PRODUCT CAMPAIGN BULLETIN

APPLICABILITY: 2019MY Ascent **NUMBER:** WUI-94R
SUBJECT: STOP SALE: Propeller Shaft **DATE:** 07/02/19
NHTSA: 19V519
REVISED: 07/22/19

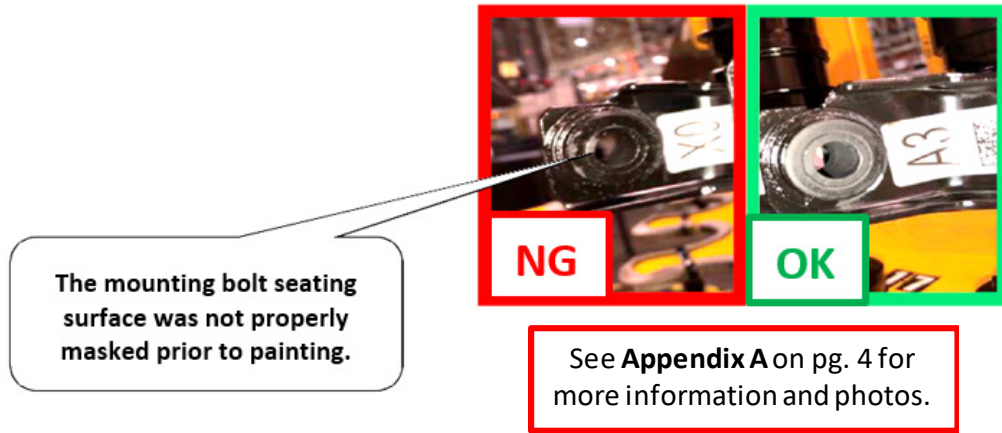
During manufacture of the propeller shaft assembly, the mounting surfaces for the two (2) center support brace bolts were inadvertently painted as shown in the **NG** example photo below. The mounting surface should be unpainted as shown in the **OK** photo. Because of this, the mounting bolt torque applied during propeller shaft installation may relax due to continued vibration. This service procedure involves replacing the propeller shaft assembly and the related hardware.

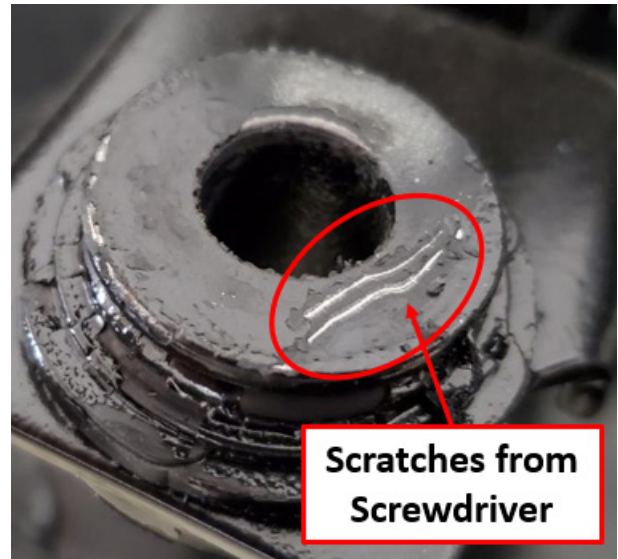
VERY IMPORTANT: After removing the original propeller shaft, confirm there is no residual **BLACK** paint remaining from the center support brace on both mounting surfaces of the body. The mounting surfaces **must be clean** as shown below. Use a mild solvent on a clean shop cloth to clean the area if necessary. **NEVER** use an abrasive disc or otherwise remove the tan-colored protective underbody finish coat. Doing so will expose bare metal making it susceptible to corrosion / rust.
